CORRIGENDUM NO. -3

PROJECT NAME: Engineering, Procurement & Construction pertaining to establishment of Rail coach factory including Civil Construction of manufacturing blocks, testing bay, other utility buildings (Non factory buildings), Railway Track sidings, water supply and distribution System, Roads, Drainage and sewerage systems, General Electric works including regular and emergency power supply and distribution system, related installations & services (Fire, Gas, Compressed air, IT, BMS, etc.), MFA (Miscellaneous fixed assets) and other Land & Site development works including grading, levelling works in connection with setting up of a Rail Coach Factory hereinafter referred as BEML RAIL HUB FOR ADVANCE MANUFACTURING (BRAHMA) near Umaria village, Obaidullaganj, District- Raisen, Madhya Pradesh (India) on EPC Mode.

TENDER No.: 6300040573

Pre-bid Meeting – BEML Response to Pre-bid Queries from Bidders - Set 2

MASTER PLAN LAYOUT

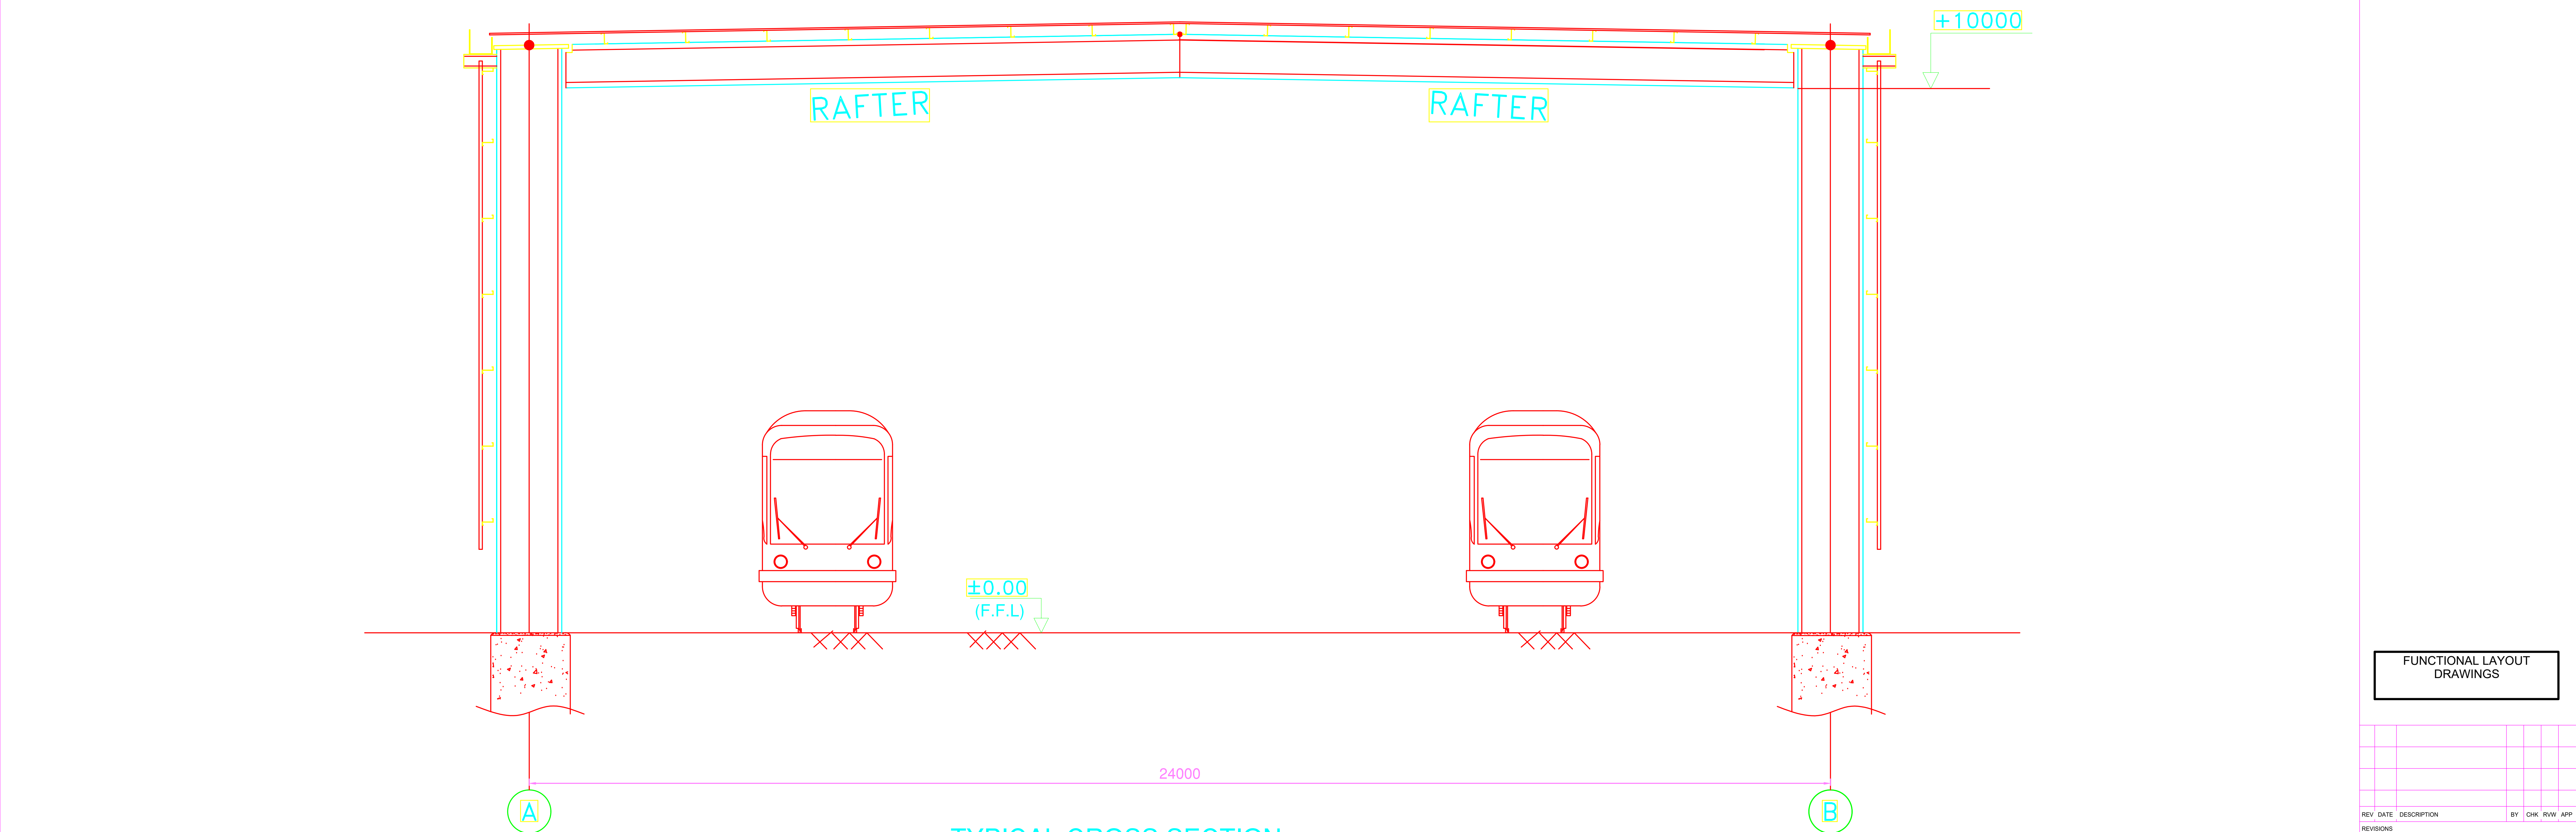
135	Apendix-C Bill of Quantities and Master Plan Layout	As per A- Land & Site Development Green Belt Area	9- Green Belt Development-37 Acres, Kindly confirm the location of green belt area to be considered, and share revised Master Plan for better clarity.	Green belt area has been shown in the drawngs and the same is provided in Corrigendum-3.
136	Master Plan Layout	Location of STP	STP in master plan is located on higher contour level which is not preferable, Kindly confirm.	The relocated STP is shown in revised layout provided in Corrigendum -3.
